Office Action Summary	Application No. 10/554,062	Applicant(s) MAGERL ET AL.	
	Examiner JAN CHRISTOPHER MERENE	Art Unit 3733

DETAILED ACTION

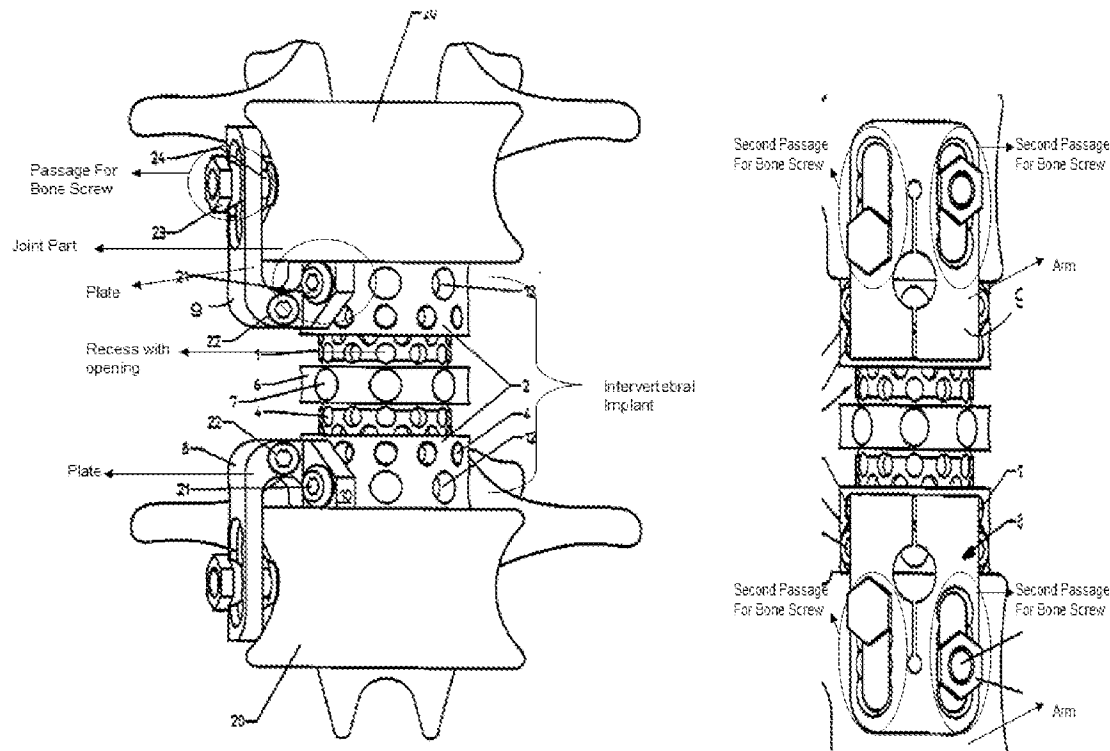
Regarding **Claim 1**, Sutcliffe discloses a device for spondylodesis and in particular for anterior intersomatic spondylodesis of the cervical spine, with at least one intervertebral implant, that functions as a pressure-absorbing spacer which stabilizes the spondylodesis and ensures that a solid osseous bridge forms between adjacent vertebral bodies and with at least one plate which is to be connected to the intervertebral implant and to an adjacent vertebra, wherein the intervertebral implant has a recess that has an opening to an outside of the implant, wherein the intervertebral

implant is connected to at least two plates, wherein the intervertebral implant extends transversely to the at least two plates which are arranged at a distance from one another, one end of each of the two plates forming a fixable joint together with the intervertebral implant (as seen in Figs below).

in **Claim 2**, at least one of the plates has a Z-shaped, I-shaped or L-shaped configuration (as seen in Fig. 4A-B, where the plate has an L-shape);

in **Claim 3**, at least one plate, in a central area extending transversely with respect to the longitudinal axis of the spinal column, has at least one passage for a bone screw, so that this plate can be connected to a vertebra (see Figs above);

in **Claim 4**, in that said area has two passages arranged at a distance from one another and each intended for a bone screw (see Figs above);

in **Claim 6**, in that at least two plates are each connected to an intervertebral implant via a polyaxial joint (see Fig above, where when the screw is loose would provide a polyaxial joint and secured when fully fastened).

in **Claim 7**, in that at least two L-shaped plates are connected to an intervertebral implant (as seen in Fig above);

in **Claim 8**, in that the two plates each have, in an arm extending transversely with respect to the longitudinal direction of the spinal column, at least two passages which are arranged at a distance from one another and each receive a bone screw (see Fig above);

in Claim 12, that it is provided for spondylodesis of the cervical spin (see Fig above and see Col 1 lines 1-5, where the device can be used in for spondylodesis).
